Alignment of the cryomodule

Report on the discussion 5th March 2018

Cryomodule survey before cooldown

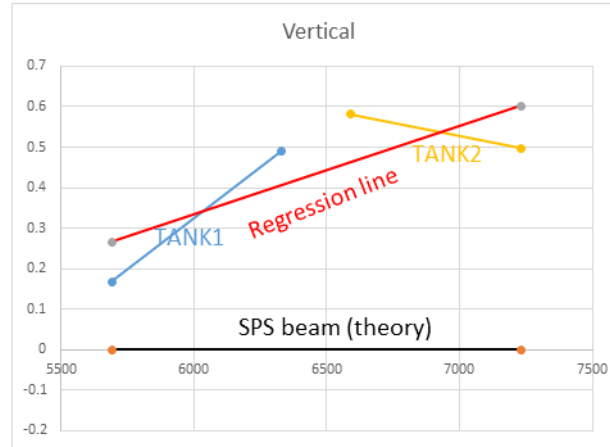
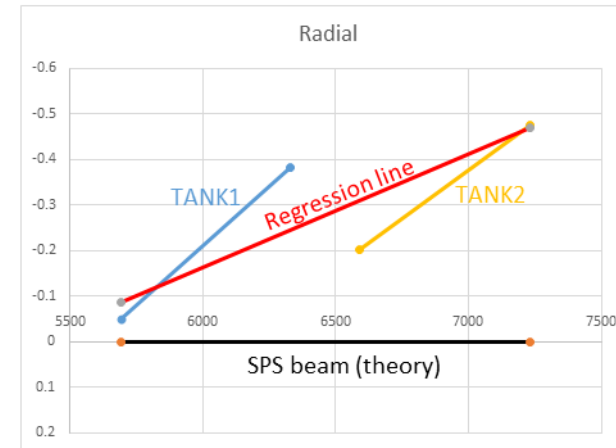
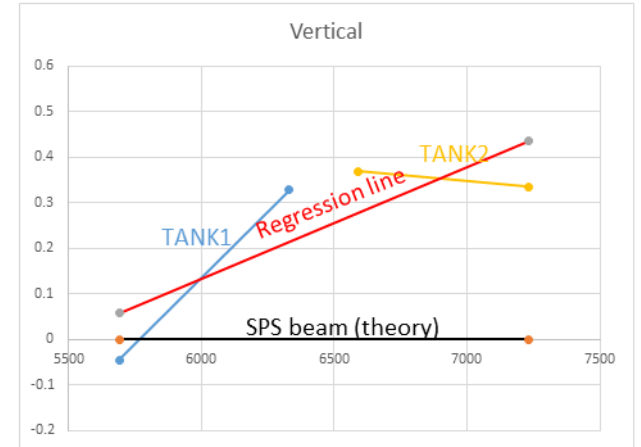
Including contraction corrections based on SM18 BUNKER measurements:

Including contraction corrections based on theoretical calculations:

According to spec, max allowable misalignment should be within +/-250 μ m w.r.t. beam

- Insufficient data on effect of vacuum cycling
- No FSI observation during initial alignment
- Successive cycles on insulation vacuum

Re-alignment movement

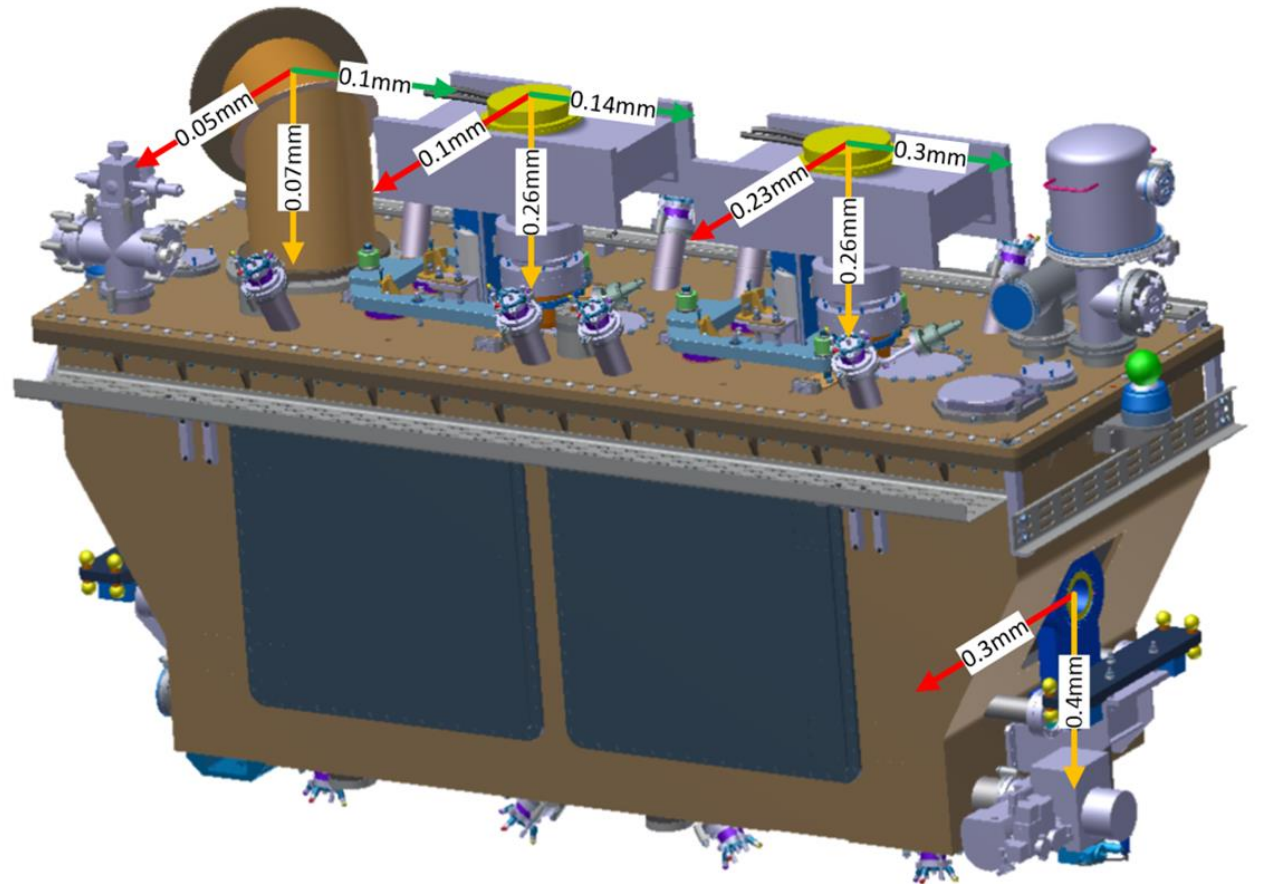
Downstream side of cryomodule

- lowered 400 μ m
- shifted radially toward corridor side by 300 μ m

Using **jack below the jumper as the pivot point**, we expect local shifts:

Jumper: 50 μ m in Radial, 70 μ m Vertical, 0.1mm in Longitudinal;

RF connection left: R0.1mm, V0.26mm, L0.14mm;

RF connection right: R0.23mm, V0.26mm, L0.3mm

Shifts only in radial-vertical directions – no expected twisting of vacuum bellows.

Shear expected:

- Cryogenics jumper
- RF bellows
